DCD Section 6.3 Clarification Call (June 7, 2016) NPSH Audit Notes and Questions

1. Page 24 of Technical Report APR1400-E-N-NR-14001-P, Rev. 0, indicates a value of 2.95 ft. for the NPSH_m. Table 3.6-2 indicates a value of 1.73 ft. for NPSH_m. Please explain the discrepancies.

Figure 3.9-3 Schematic Diagram for IRWST Water Volume

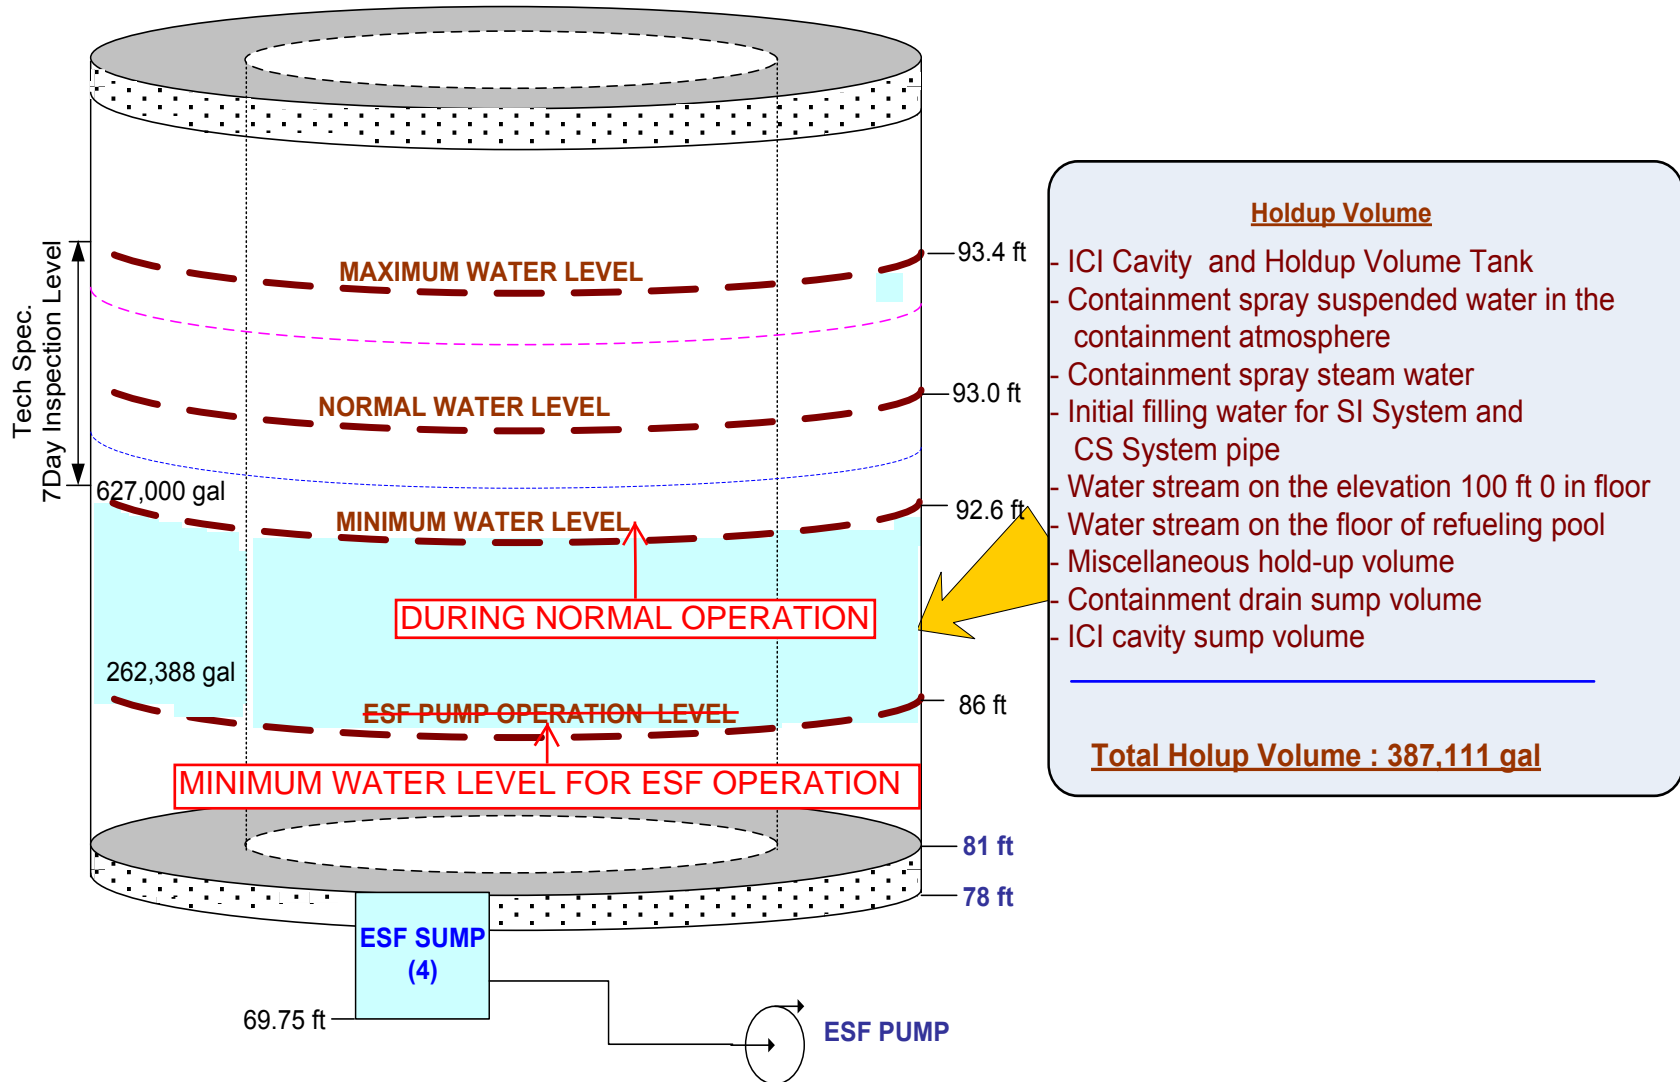
3. Figure 3.9-3 of APR1400-E-N-NR-14001-P – clarify the values used to calculate 262,388 gallons.

Response

During normal operation, the IRWST water level is maintained at 93.0 ft. (elevation, EL) (77.04%, 649,000 gal). The IRWST is designed to minimize water evaporation, however, if the IRWST water level is less than 92.6 ft. (EL) (74.43%, 627,000 gal, the water level is recovered by a makeup operation from the boric acid storage tank via the boric acid makeup pump. Therefore, the water level of 92.6 ft. (EL) is the minimum IRWST water level during normal operation and becomes the initial water level for postulated accidents.

The calculated IRWST water level for ESF operation during a LOCA is calculated by subtracting the holdup volume and inactive pool volume from the initial water volume at 92.6 ft. (EL) followed by adding the volume of three SITs, as follows:

$$V_{ESF, \text{ calculated}} = V_{\text{Initial}} - V_{\text{Holdup}} - V_{\text{Inactive}} + V_{\text{SIT}} = 280,056 \text{ gallon}$$

Since the instrument lower tap height of 0.25 ft. is considered above the IRWST floor of 81 ft. (EL), the actual IRWST water level for ESF operation from the IRWST floor becomes 86.32 ft. (EL) (81 + 5.07 + 0.25 ft.).

The design basis of the minimum IRWST water level for ESF operation is set at 5 ft. above the IRWST floor, or 86 ft. (EL), with a margin of 0.32 ft.

Therefore, the water volume at 86 ft. (EL) of the IRWST water level becomes the minimum water volume for ESF pumps operation. The V_{ESF} volume of 262,388 gal is calculated as follows.

$$\begin{aligned} V_{\text{ESF}} &= \pi (IRWST \text{ outer radius}^2 - IRWST \text{ inner radius}^2) \\ &\quad \times (\text{Minimum water level for ESF operation} - IRWST \text{ lower tap level}) \\ &= \pi (71.83 \text{ ft}^2 - 53 \text{ ft}^2) \times (86 \text{ ft} - 81.25 \text{ ft}) = 262,388 \text{ gal} \end{aligned}$$

In order to clarify these points, DCD, Subsections 6.2.1.1.2.2 and 6.8.4.5.8, and TeR, Subsections 3.6.2, 3.9.1, 3.9.2, and Figure 3.9.3 will be revised as shown in Attachment 2 and 3.

The minimum water level of the IRWST  during a LOCA is calculated by subtracting the holdup volume from the initial water volume in the IRWST and by adding the volume in three SITs. The minimum water level used in the NPSH evaluation is calculated as 1.52 m (5 ft) above the IRWST bottom (El. 81 ft) and is shown in Figure 3.9-3.
